Type of Survey Hydrographic
Field No. FA-10-4-81
Office No. H-9973

State Alaska
General Locality Shelikof Strait
Locality Western Amalik Bay

PACIFIC MARINE CENTER
EVALUATION REPORT

REGISTRY NO: H-9973

8th Ed., Oct. 31/81
16580
LORAN-C OVERPRINTED

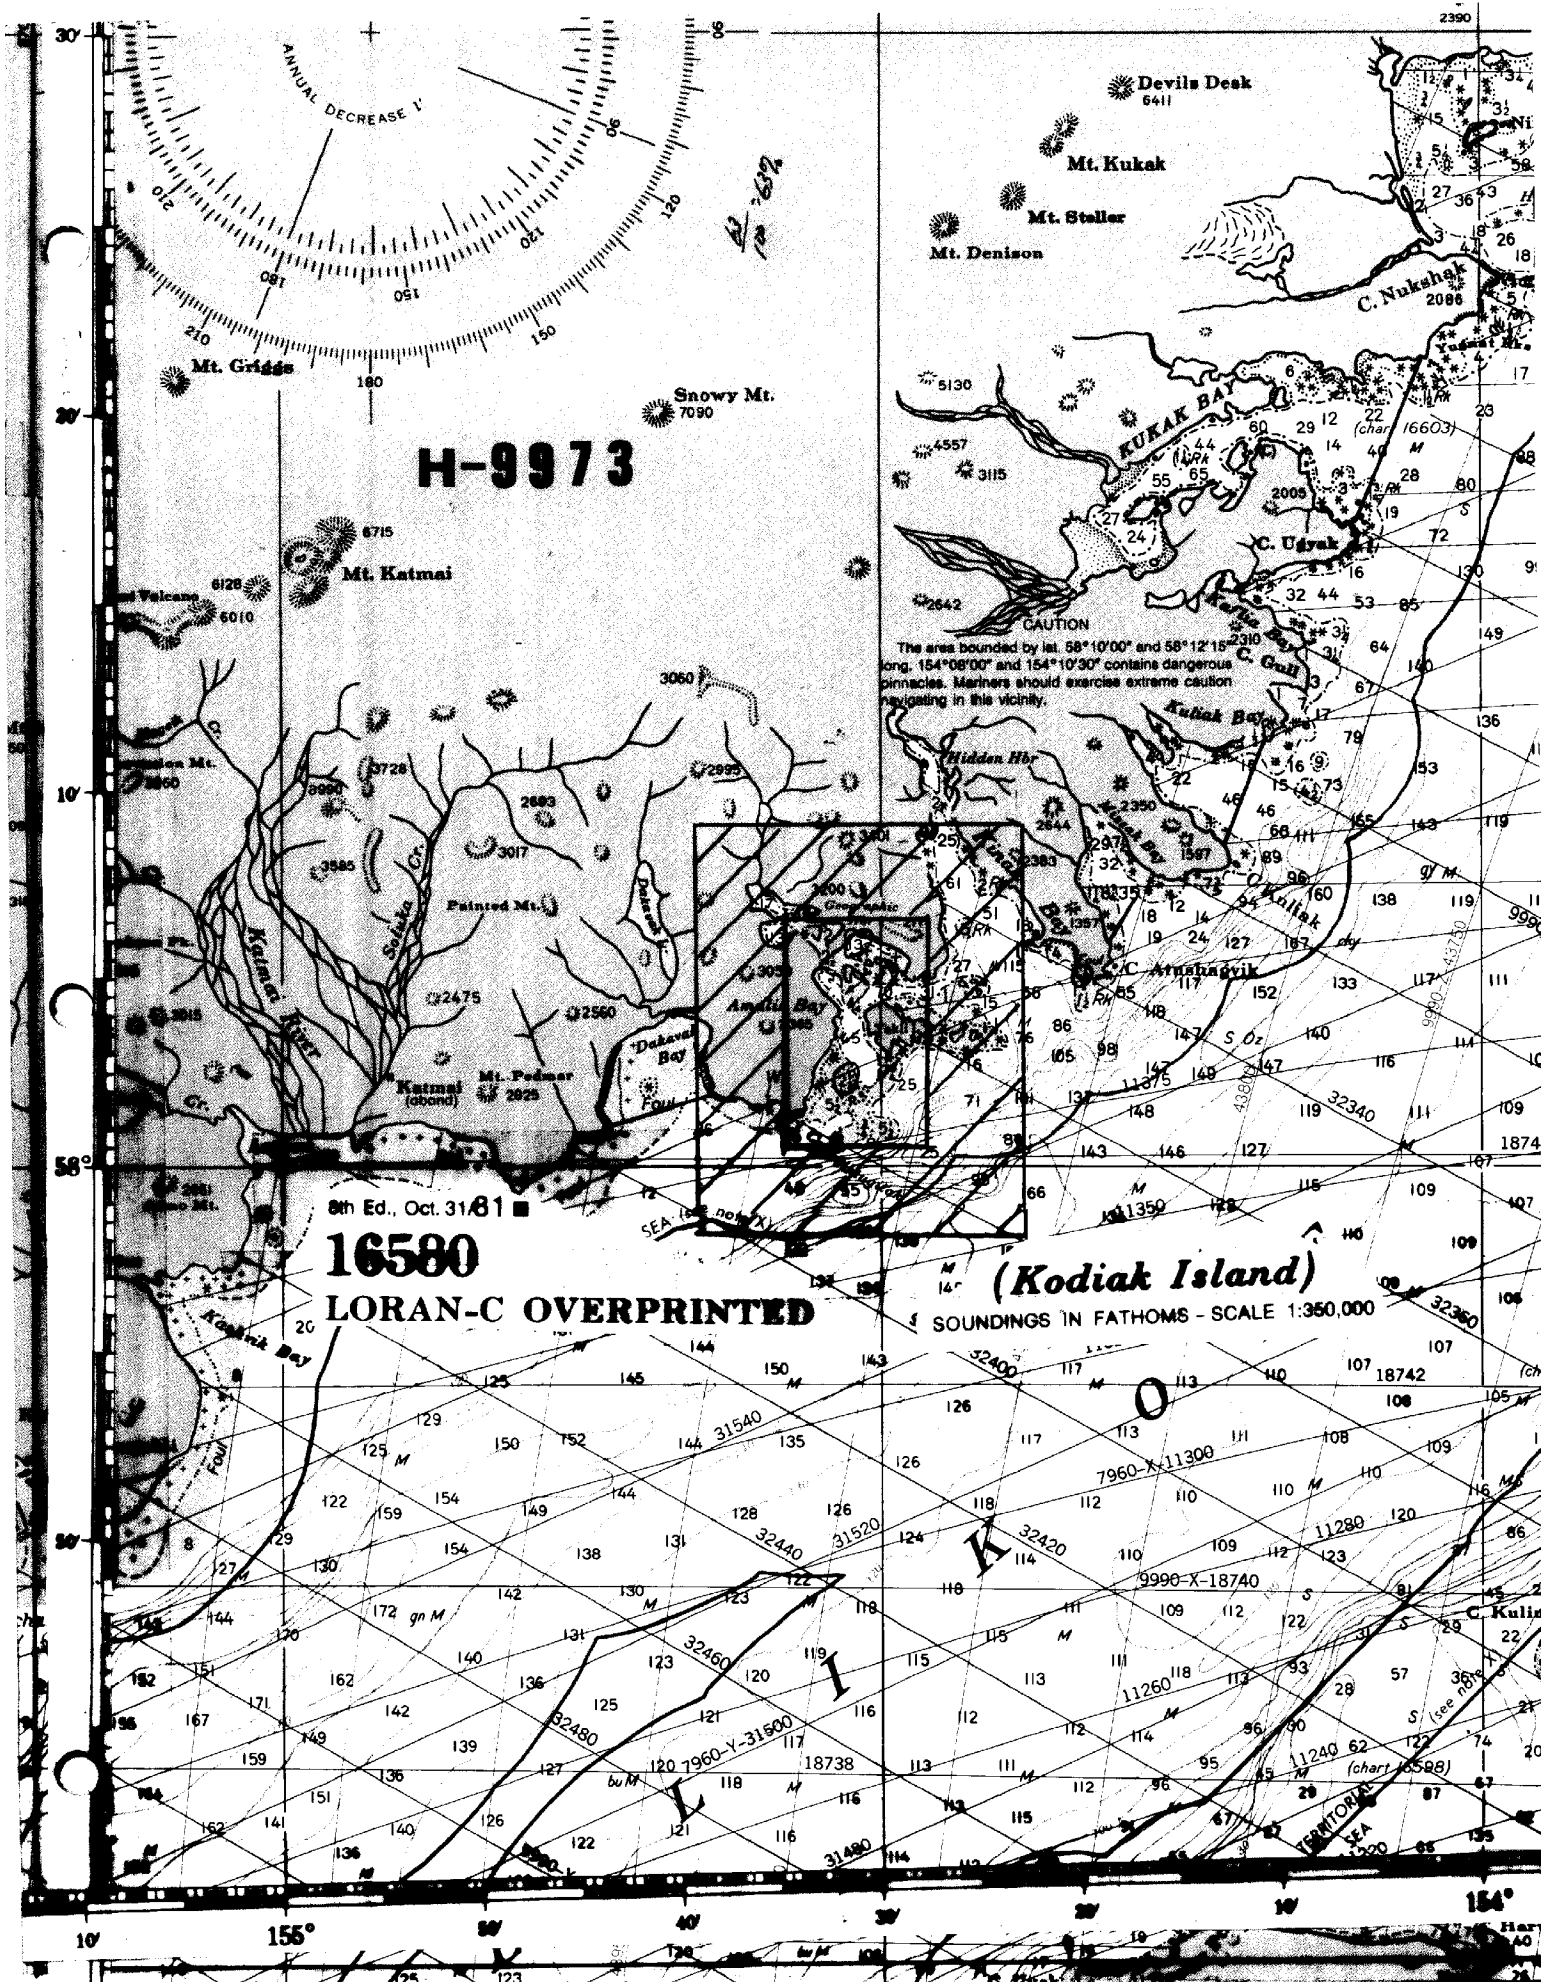
a. Hydrography - Charted information comes from an unknown source (see enclosed chartlet). There are two soundings from the chart that are within the survey limits:

(1) 13 fathom sounding at latitude 58°05'51"N, longitude 154°31'18"W. This sounding matches sounding data on H-9973.

(2) 2.5 fathom sounding at latitude 58°02'18"N, longitude 154°31'39"W. This sounding is 150 meters away from a 2.5 fathom sounding on H-9973 (position number 6222/1).

H-9973 is adequate to supersede the chart over their common areas.
